Application for Works Approval

Works Approval Number W6175/2018/1

Premises Witchcliffe Eco Village WWTF
10437 Bussel Highway
WITCHCLIFFE WA 6286

Date of Report 24 September 2019

Figure 11. Data from soil test-pits and groundwater monitoring bores showing areas where the depth to the ferruginous hardpan is less than 1.0 metres and where the depth to groundwater is less than 1.5 metres

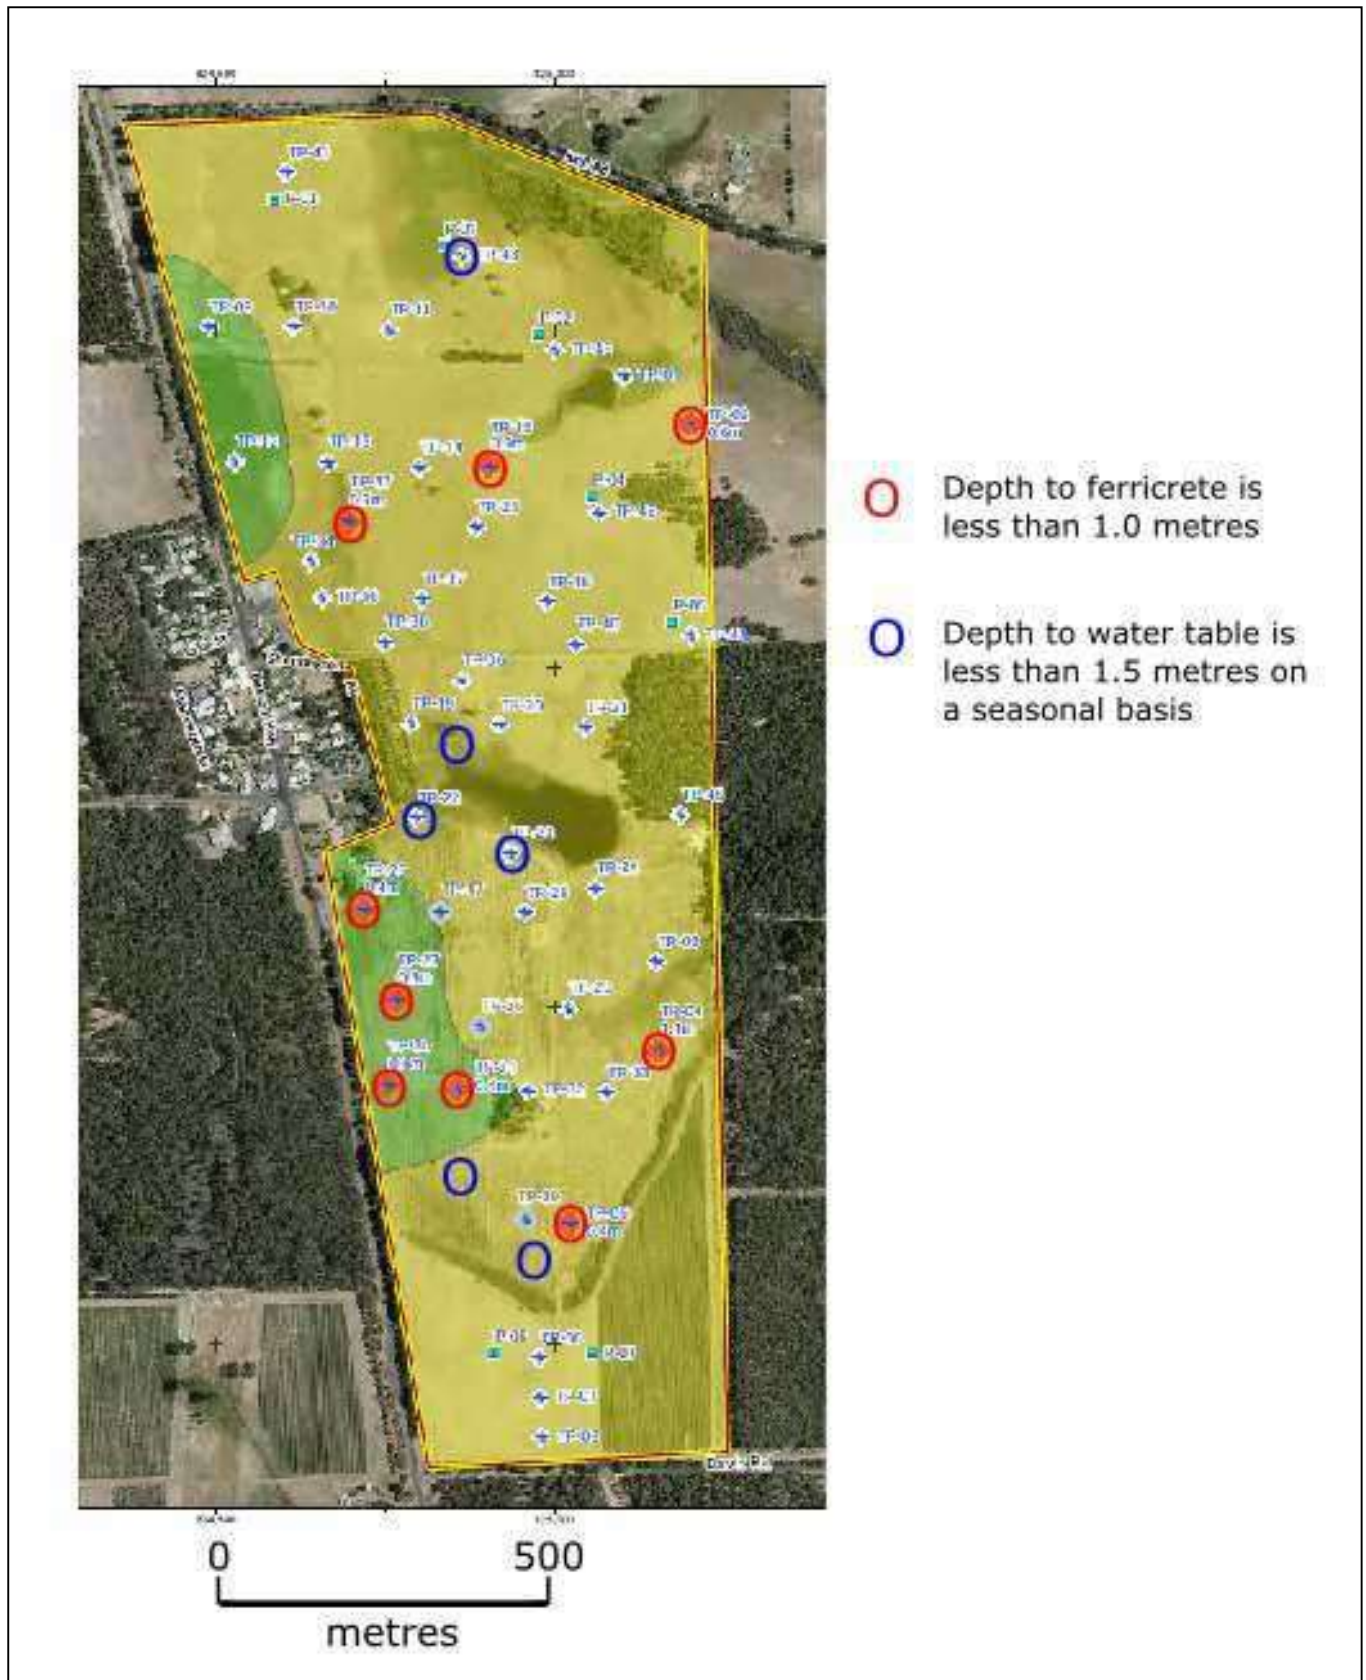
The Applicant provided an additional report and soil monitoring results in response to the draft Works Approval and Decision Report. The report indicates that constant-head permeameter tests were carried out at five locations across the site to a depth of approximately 0.5m. The Applicant has also undertaken an assessment of the soil testing parameters against the New South Wales Department of Environment and Conservation Environmental Guideline *Use of Effluent by Irrigation*, 2003 and noted that no severe limitations to the irrigation site were identified.

DWER has reviewed the additional information provided and notes that whilst no severe limitations were identified with soils in the irrigation area, the number of soil samples from the irrigation area itself is still quite limited. As such, DWER considers it appropriate that additional soil testing is undertaken to validate the suitability of the soil for long-term irrigation purposes.

Premises Map

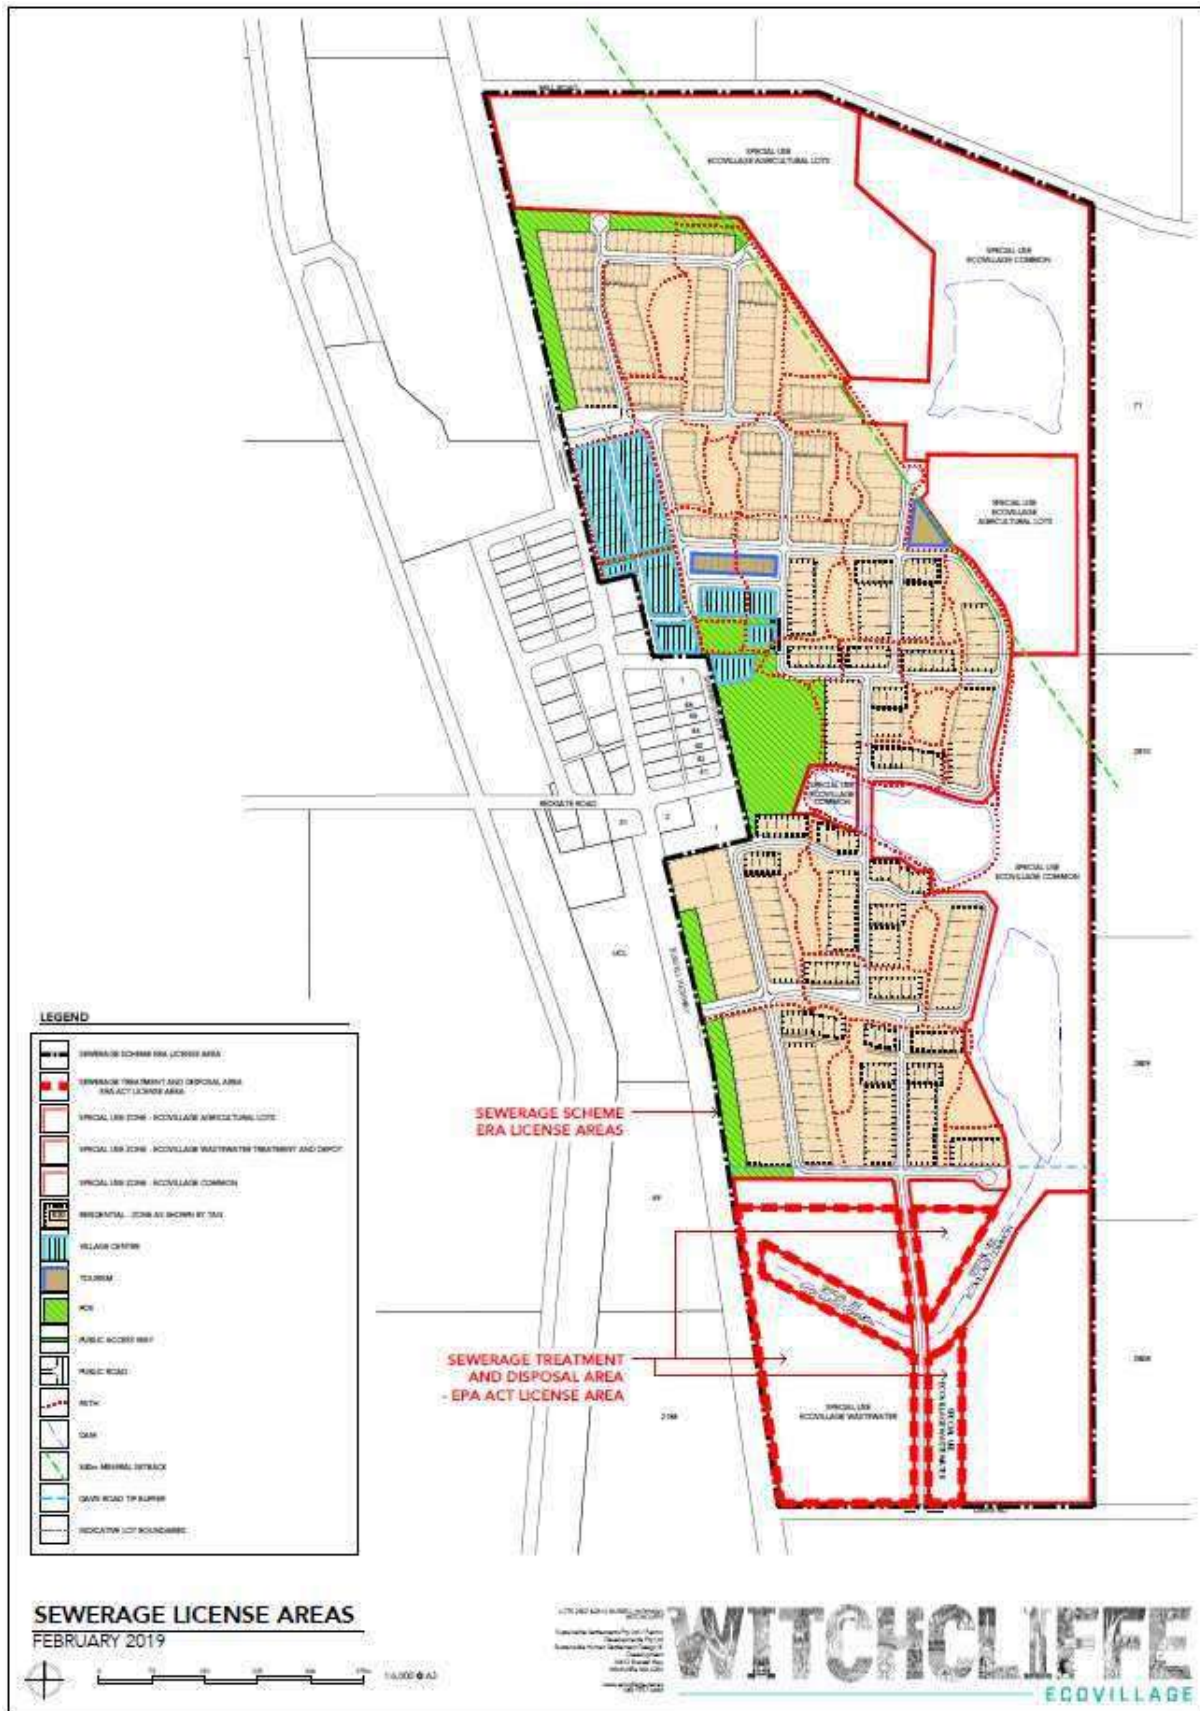
Works Approval condition / Decision Report section	Comment	DWER response
	months for subsequent stages will be satisfactory.	
<p>Schedule 1 – Premises Map</p> <p>DWER requested a revised map encompassing the whole area on which the relevant activity on the prescribed premises takes place and from which emissions and discharges from that activity would occur.</p>	<p>Applicant provided a revised Premises map.</p> <p>The Prescribed Premises area is annotated “Sewage Treatment and Disposal Area – EPA Act License area”. The area has been updated for consistency with the irrigation area plan.</p> <p>The sewerage scheme area for ERA licensing under the Water Services Act is also included on the plan but does not constitute part of the Prescribed Premises.</p>	<p>The Works Approval has been updated with the revised map.</p>
<p>Schedule 1 - Irrigation Area Site Plan</p> <p>DWER requested confirmation that the irrigation plan correctly identified all irrigation areas and requested confirmation as to the sizing of the effluent lagoon.</p>	<p>The Applicant advised that the irrigation plan correctly identifies the irrigation area however the winter storage lagoon was revised from 25ML to 30ML based on the results of the water balance and MEDLI model prepared by Permeate Partners and the position of the storage lagoon and treatment plant has been updated with progress of the detailed design. An updated irrigation area plan showing the revised irrigation lagoon sizing and position has been provided.</p>	<p>Noted, the Irrigation Plan has been updated and references to 25ML removed in the Decision Report and Works Approval.</p>

Wastewater Irrigation System Plan

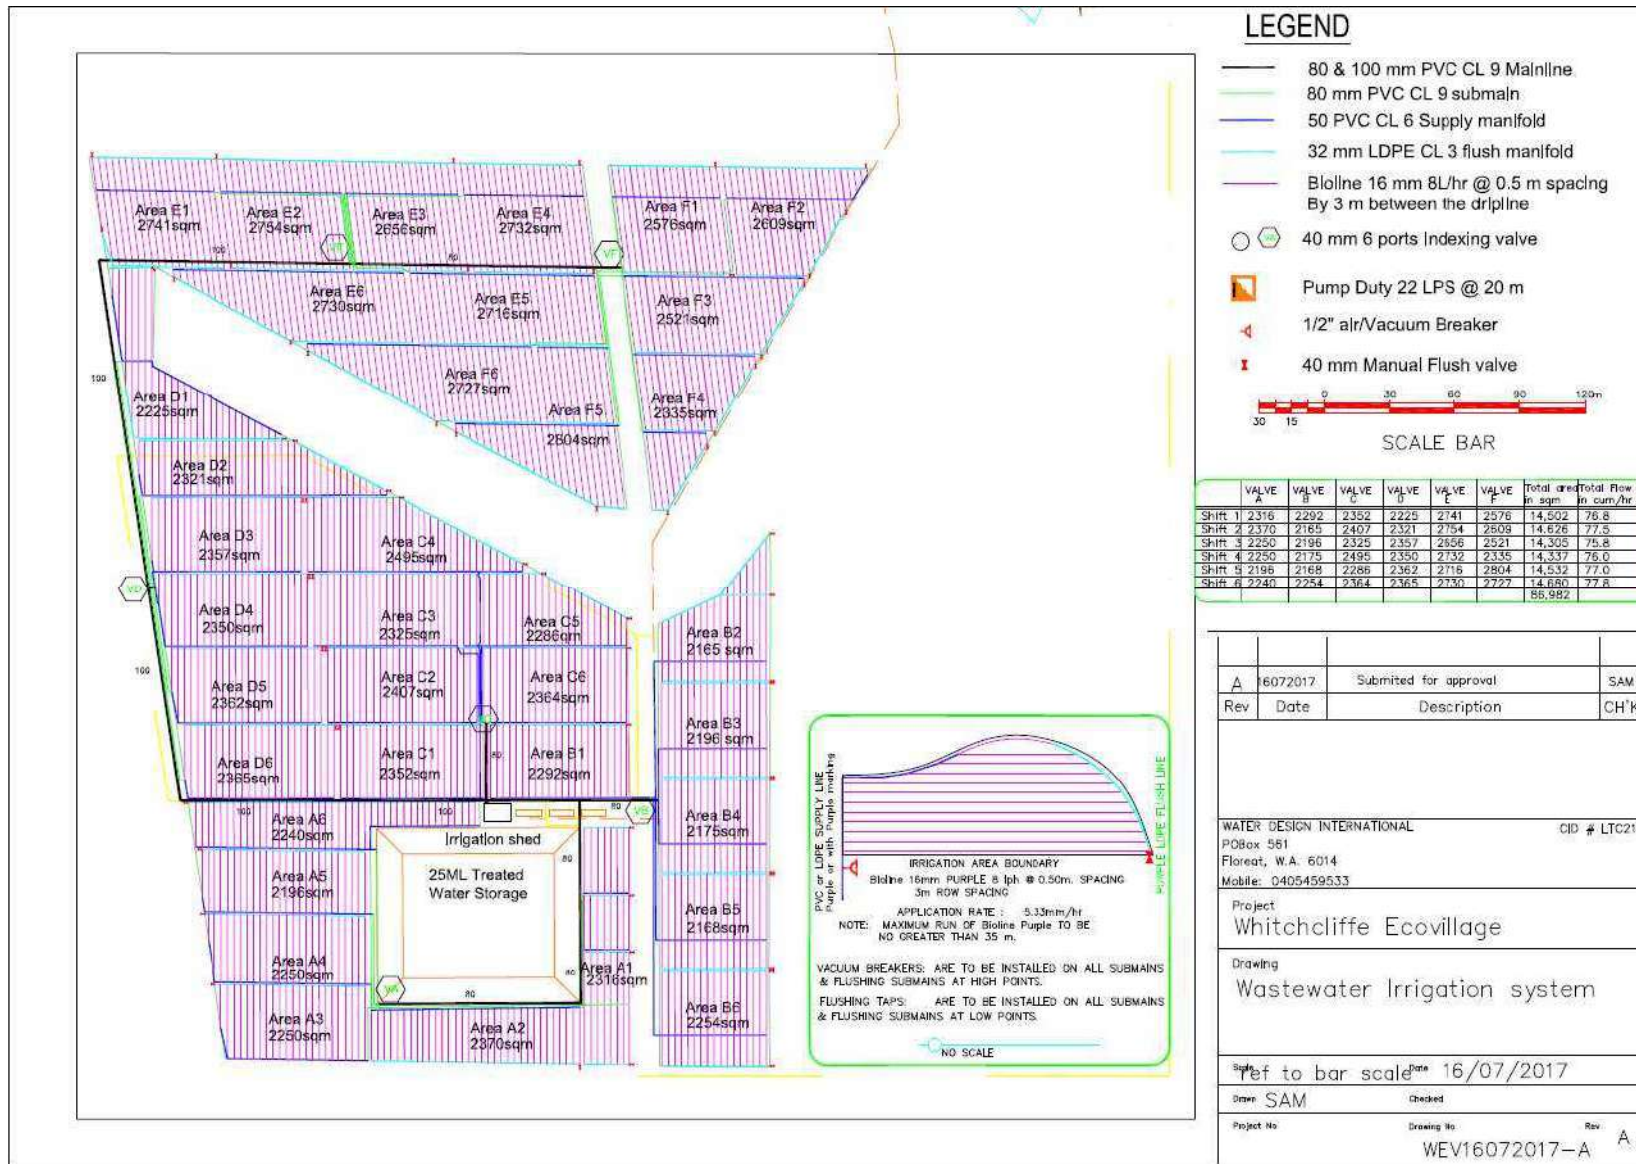
Schedule 2 – Infrastructure and requirements DRAIMAD dewatering unit specifications	Specifications provided by the Applicant in an attachment.	Noted, specifications have been amended in the Decision Report and Works Approval.
Schedule 2 – Infrastructure and requirements Wet weather storage dam site plan reference and confirmation of size	The wet weather storage dam (treated water storage lagoon) is 30ML in size. An updated site plan has been provided by the Applicant.	Noted, the Works Approval has been amended to include the revised site plan.
Schedule 2 – Infrastructure and requirements Applicant to confirm that the sizing of irrigation area is at least 8.4Ha in size.	The Applicant confirmed that the total prescribed area is 10.3Ha in area and that at least 8.4Ha is available within this area for irrigation.	Noted, the Works Approval has been amended to include the revised irrigation plan.
